# FINAL DRAINAGE REPORT

## Lot 3A Northcrest Center Filing No 1A

PCD File #PPR2412

March 30, 2024

Figure 12-21. Embankment protection details and rock sizing chart (adapted from Arapahoe County)

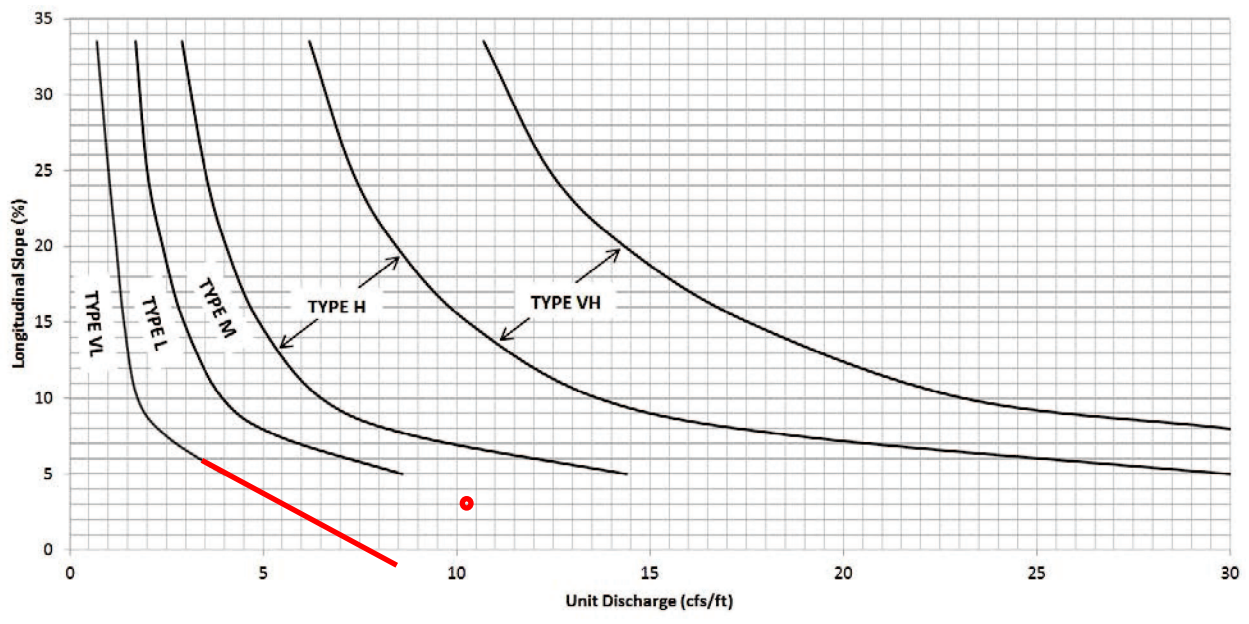
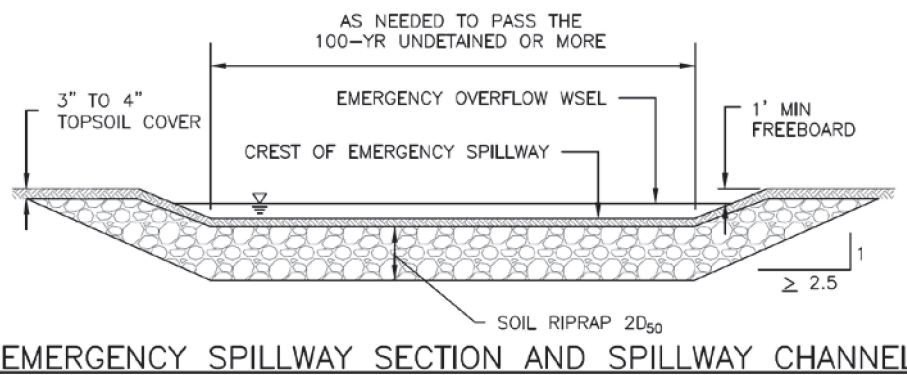
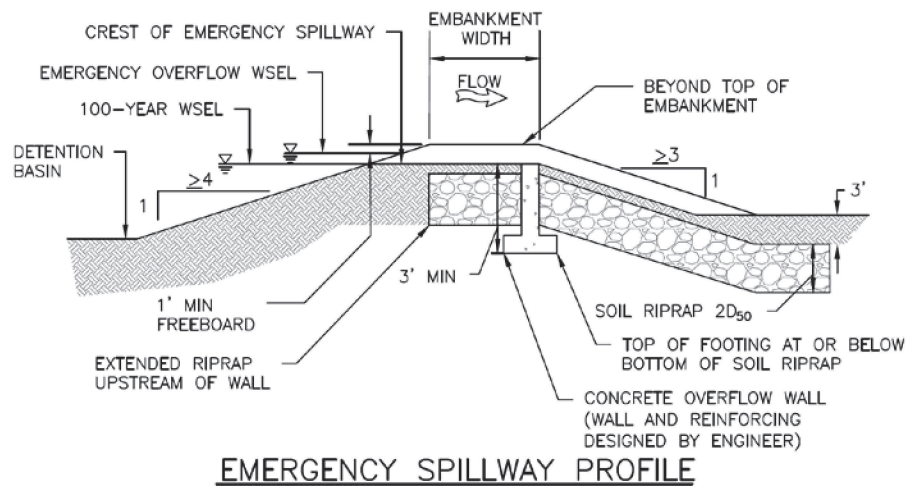
Incorrect property
